**POLARIS**<sup>®</sup>  
*Racing*

**TIP # 11 2005 440 IQ - Reed Petal Replacement.**

**New Reed Petal packaging vs. old.**

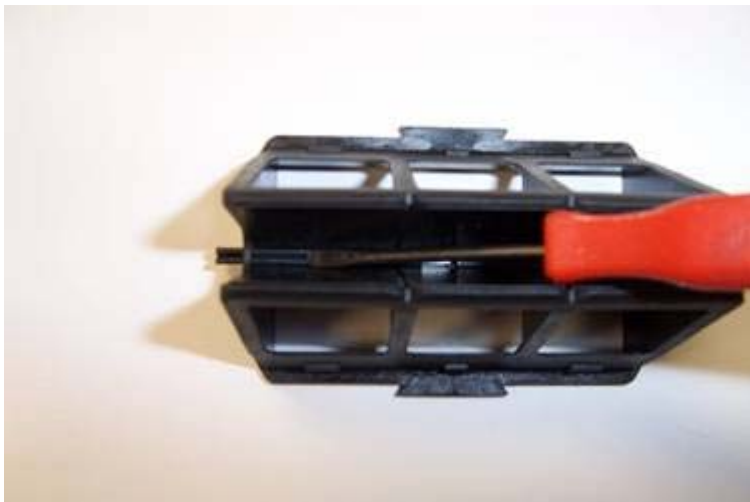
Due to a material defect we have sent replacement reed petal kits to all Polaris racers. The new reeds can be identified by smaller print on the bar code label and a shinier black color on the reed petals.

To replace the reed petals, separate the reed cage from the outer housing, Use a small flat blade screwdriver to drive the center petal retainers outward. Use pliers to pull the petal retainers out of the reed cage and discard. Install the new reed petals, and petal retainers supplied in the kit.
